Access Compliance Report

Public Rights-of-Way

Intersection ID: 45172	Main Street: ELDON_DR	Cross Street: LINDEN_TREE_LN	Location: SE
ADA ID: 92AA009E4D7C	Ramp Type: BlendTrans1	Initial Pass/Fail: Pass	Overall Compliance: No
			Severity Score: 15.25

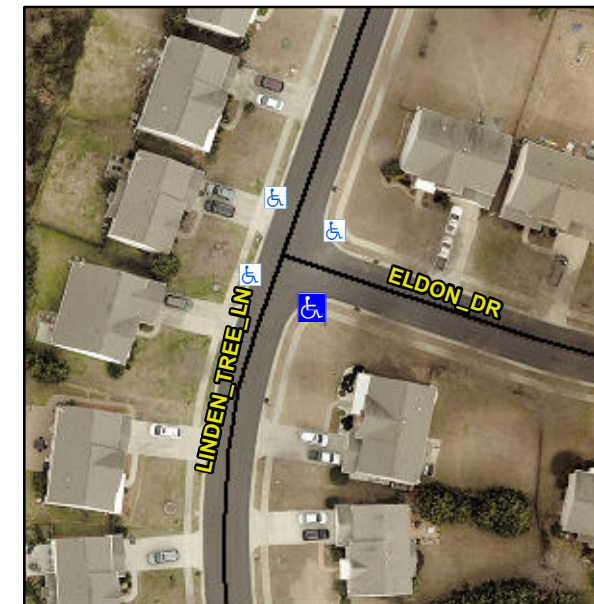
Not Found, R304.5.3, R305, R304.5.4

Compliance	Description	Data	Compliance	Description	Data
N/A	Ramp Length (in)	47.0	Yes	BlendTrans Slope (%)	4.7
Yes	Ramp Width (in)	53.0	No	BlendTrans XSlope (%)	4.4
N/A	Flare Type LT	Sloped	N/A	Flare Type RT	Sloped
N/A	Flare Slope LT (%)	2.5	N/A	Flare Slope RT (%)	0.4
N/A	Flare Traversable LT?	No	N/A	Flare Traversable RT?	No
Yes	Landing Length (in)	48.0	No	DWS Provided?	No
Yes	Landing Width (in)	53.0	N/A	DWS Contrast?	No
Yes	Landing Slope (%)	1.1	N/A	DWS Length (in)	N/A
No	Landing X Slope (%)	3.6	N/A	DWS Full Width?	No
N/A	Landing Curb? (Y/N)	No	N/A	DWS Offset (in)	N/A
N/A	Shared Landing?	No			
Yes	Gutter Ponding?	No	No	Gutter Slope (%)	5.6
Yes	Gutter Lip Ht (in)	0.0	No	Gutter X Slope (%)	3.3
N/A	Painted X Walk1?	No	N/A	Painted X Walk2?	No
	X Walk 1 Direction	To NE		X Walk 2 Direction	To NW
	X Walk 1 Width (in)	N/A		X Walk 2 Width (in)	N/A
	X Walk 1 Slope (%)	1.6		X Walk 2 Slope (%)	2.2
	X Walk 1 X Slope (%)	1.8		X Walk 2 X Slope (%)	0.1

N/A	Ramp inside XWalk1?	N/A	N/A	Ramp inside XWalk2?	N/A
	Road Slope (%)	2.0		Clear Space?	Yes
	Road X Slope (%)	1.2	N/A	Clear Space to XWalk (in)	N/A
Yes	Any Obstructions?	No	Yes	Storm Grate/Utility Hazard?	No
	Obstruction Type			Storm Grate/Utility Type	
		N/A			N/A
			Yes	Surface Condition? (G/P)	Good
			No	Curb Slope (%)	18.6

Remove & Replace Curb Ramp With Two New Directional Ramps or Equivalent. Remove & Replace Gutter.
